Development Permit with Variances Application No. 000404 for 701 Tyee Road

Council Report For the Meeting of March 10, 2016

Development Permit with Variances Application No. 000404 for 701 Tyee Road

Planning and Land Use Committee Report For the Meeting of October 1, 2015

A3.07

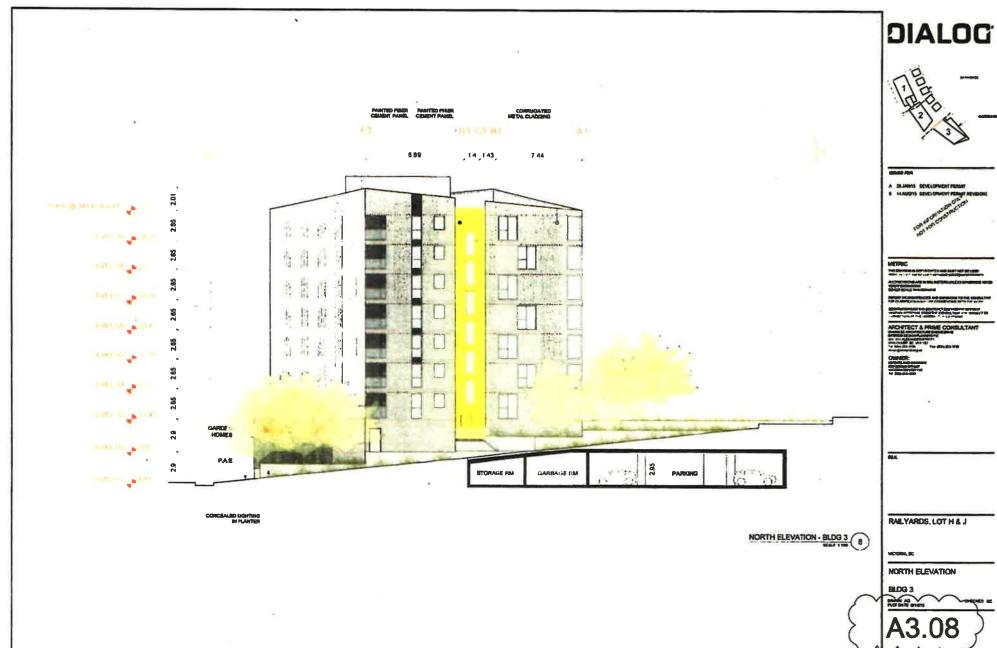
See the Architectural drawing, A3.11. The Building 3 rooftop finishes at geodetic height, 31.00m, the maximum allowable height. The only elements built above are the elevator mechanical room and parapet walls for roofscape articulation. All the habitable space will be under the maximum allowable height. To create a meaningful gateway feature at the base of the bridge head, we strongly believe that these roof articulations are necessary from the urban design perspective and worth supporting.

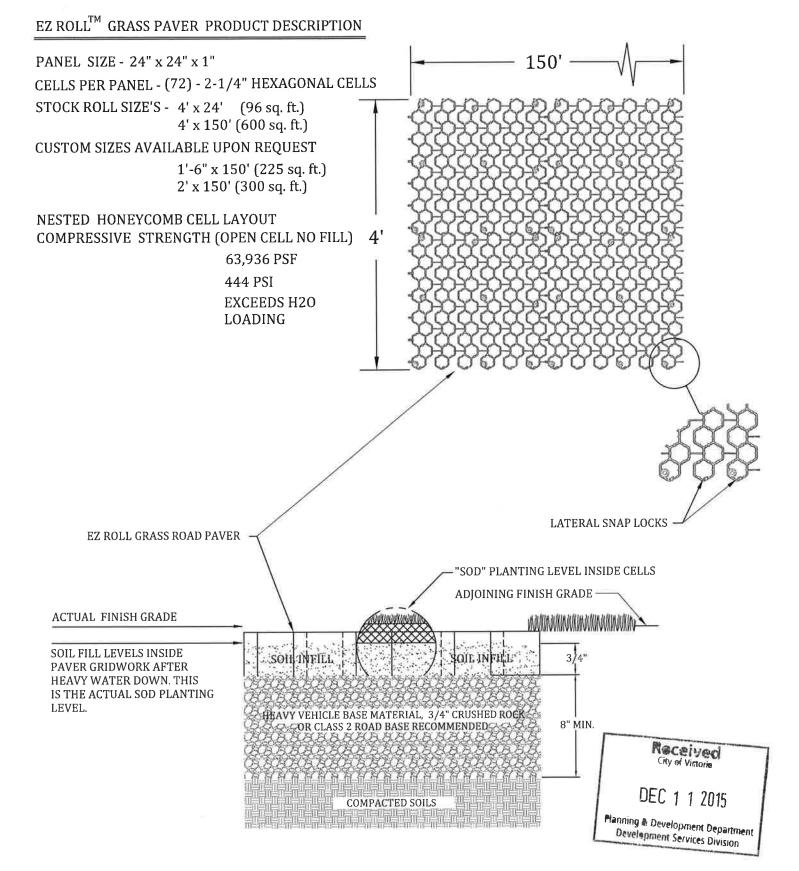
The Application proposes extensive areas of grass pave surface treatment to accommodate emergency fire truck access adjacent to Tyee Road. Staff recommend that Council consider requesting that the applicant provide further details of the grass pave treatment to ensure it is both visually acceptable and has long term durability.

- either enclose or screen the proposed garbage enclosure adjacent to Gaudin Road; Screen to be provided to hide the garbage enclosure, see A3.03
- provide further details of the grass pave finish; Attached are to supplementary details from Civil Engineer towards additional information for Fire truck lane. These will be developed further and stamped by Civil for the Building Permit.
- provide comprehensive details relating to landscaping for Phases 1 and 2; See L0.01 L0.13
- provide reduced annual landscaping maintenance costs within Bridges Park and along Tyee Road. We have worked closely with City Parks Staff to develop a landscape treatment that effectively reduces the associated maintenance costs with these noted areas.

$\underline{\text{GRASS SEED OR SOD}}$ TYPE TO BE AS SPECIFIED IN THE CONTRACT DOCUMENTS OR BY DESIGN LANDSCAPE ARCHITECT.
